**IFB113093 Kennedy Tower Window Replacement**

**ADDENDUM NO. 1**

**Rochester Housing Authority**  
**Kennedy Tower Window and Metal Panel Replacement**  
**HUNT 2285-046**

**Architectural ADDENDUM No. 1**

AD-A1

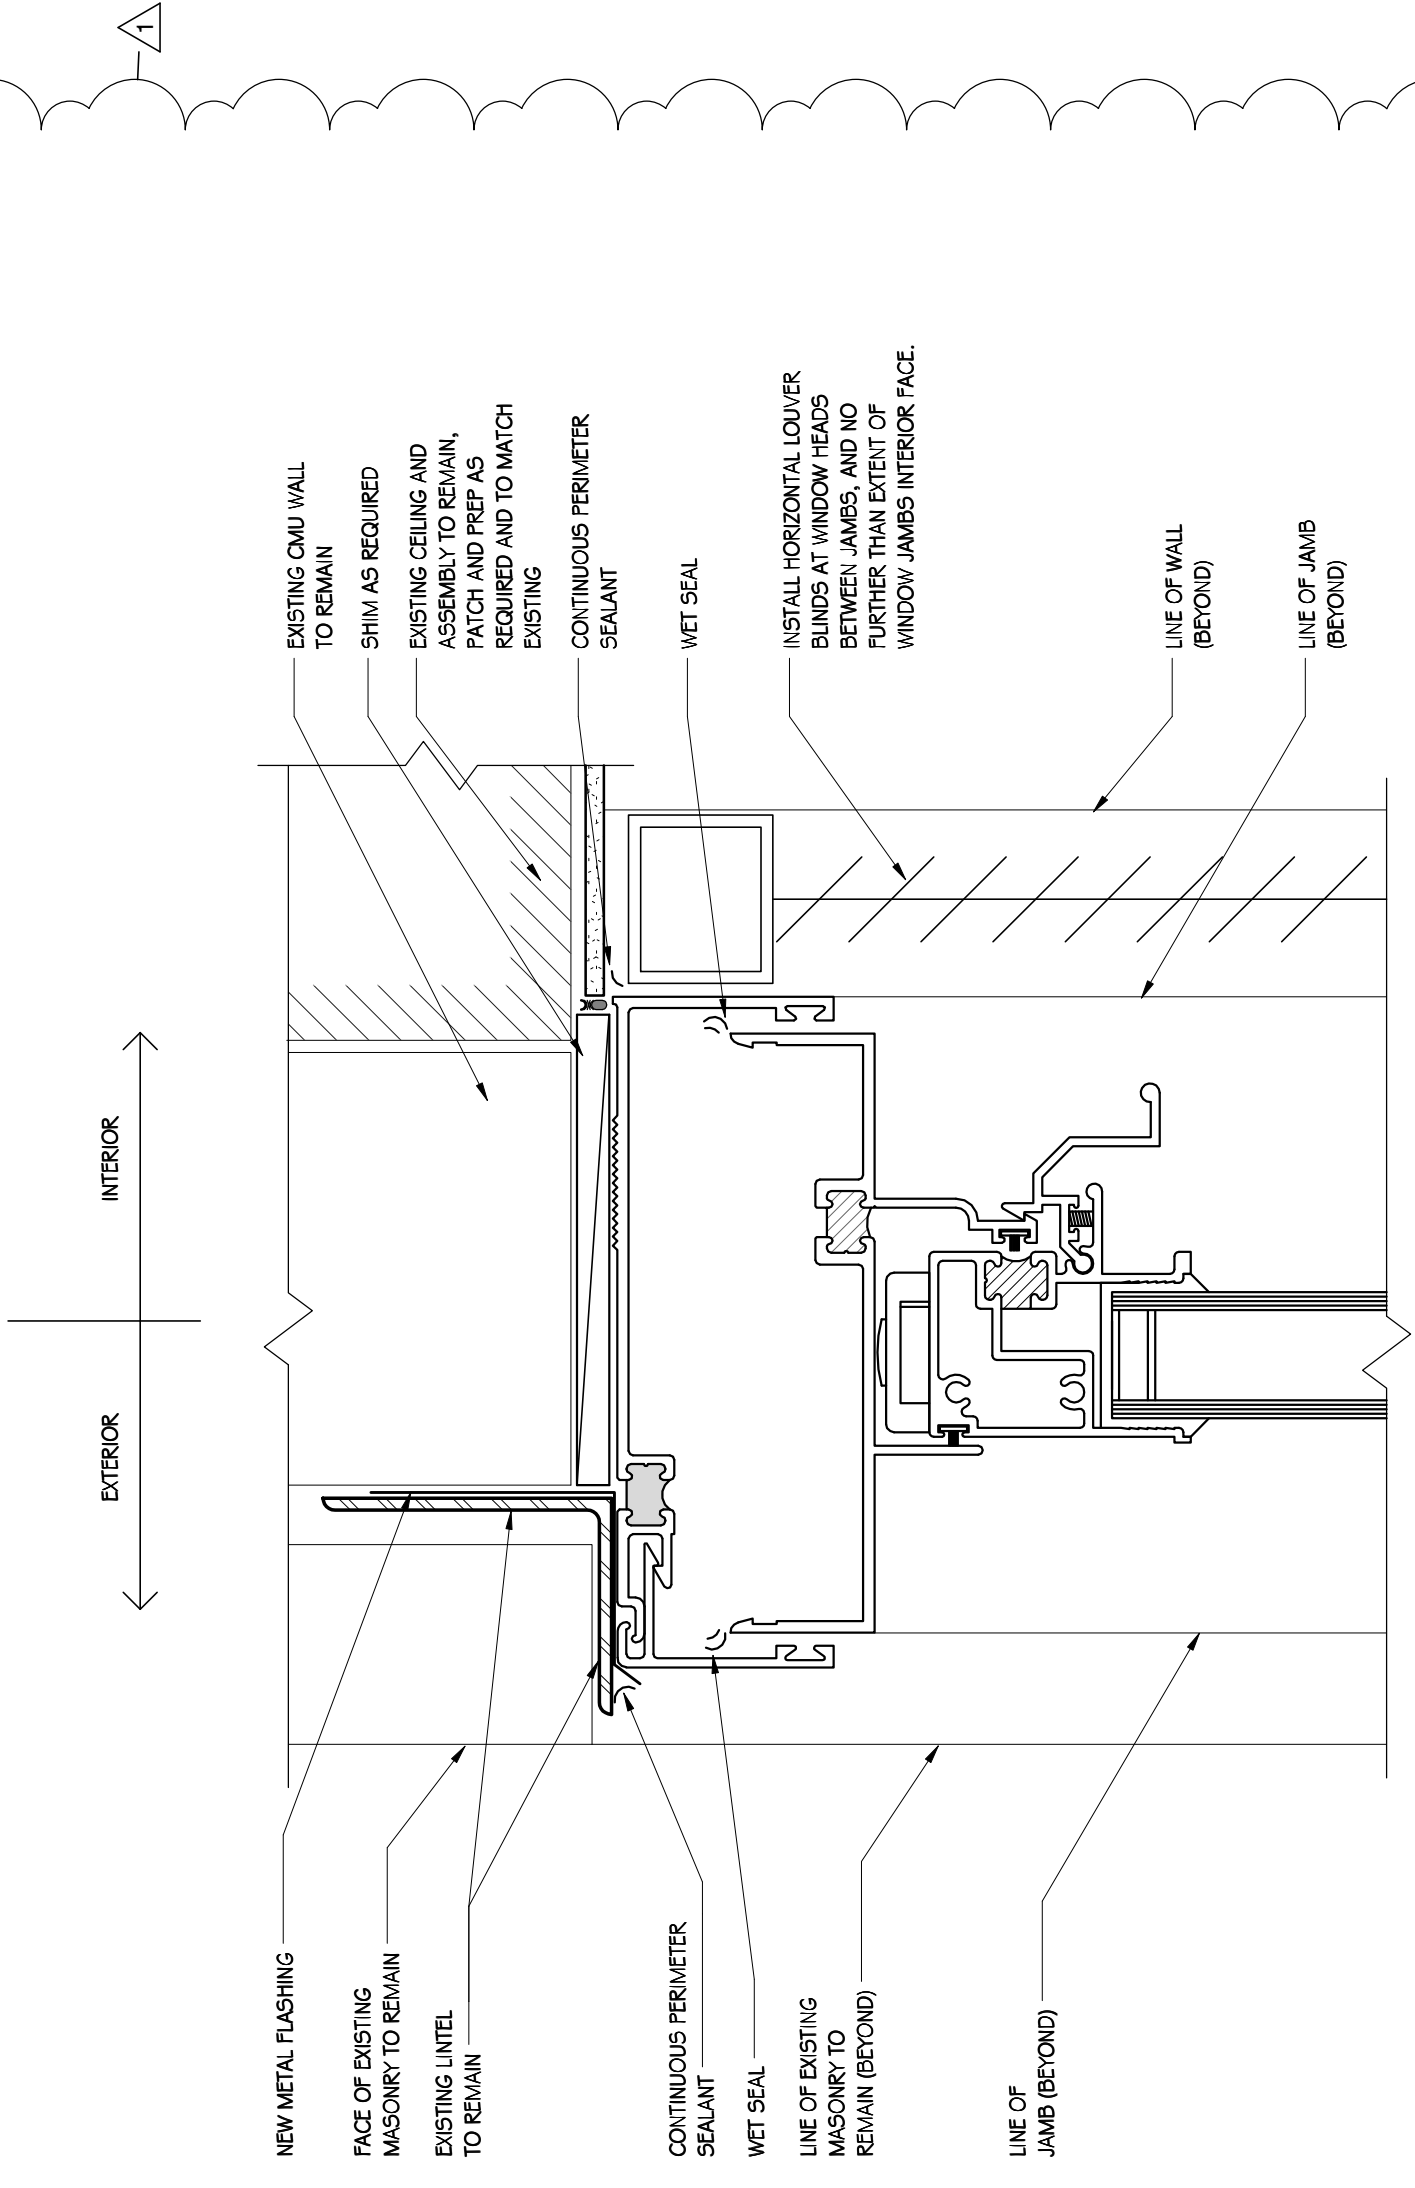
**ITEM AD1-2**    Refer to Drawing A3.2 WINDOW DETAILS Detail 7  
**ADD "INSTALL HORIZONTAL LOUVER BLINDS..."**
